SI14.40-W-0011A	Service Information: Repair solution for pressure reducing valve in pump module of exhaust aftertreatment system	21.10.10
-----------------	--	----------

MODEL 375.3 /4, 930, 932, 933, 934, 940, 942, 943, 944, 950, 952, 953, 954, 957, 958.2 with CODE (MS4) BlueTec 4
MODEL 375.3 /4, 930, 932, 933, 934, 940, 942, 943, 944, 949, 950, 952, 953, 954, 957, 958.2 with CODE (MS5) BlueTec 5
MODEL 375.1, 958.0, 970, 972, 974, 975, 976 with CODE (MS4) BlueTec 4
MODEL 375.1, 958.0, 970, 972, 974, 975, 976 with CODE (MS5) BlueTec 5

Shown: pump module A 000 140 04 78 with repair solution, external pneumatic pressure reducing valve

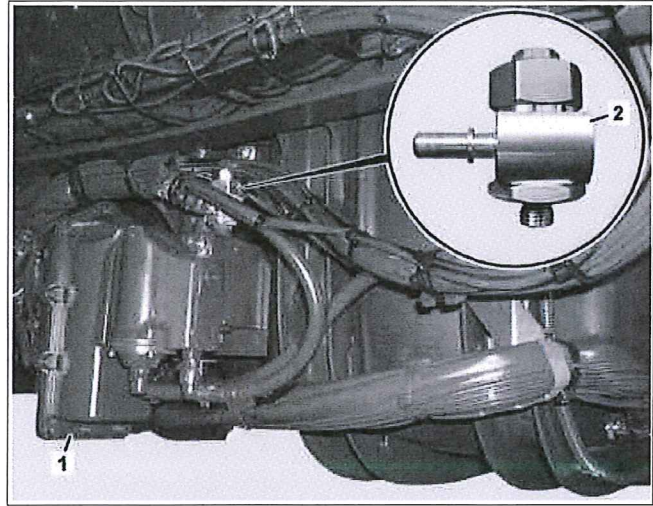
- **Pump modules with part number: A 000 140 04 78**
In the case of damage an external pneumatic pressure reducing valve (2) can also be installed here, which takes over the function of the internal pressure reducing valve. No additional work must be performed for these pump module variants.
- **Pump modules with part number: A 000 140 05 78**
This pump module does not have the internal pneumatic pressure relief valve fitted in the piston valve type, but rather an internal pneumatic pressure relief valve of the diaphragm valve type. It can be replaced in a case of damage occurring.
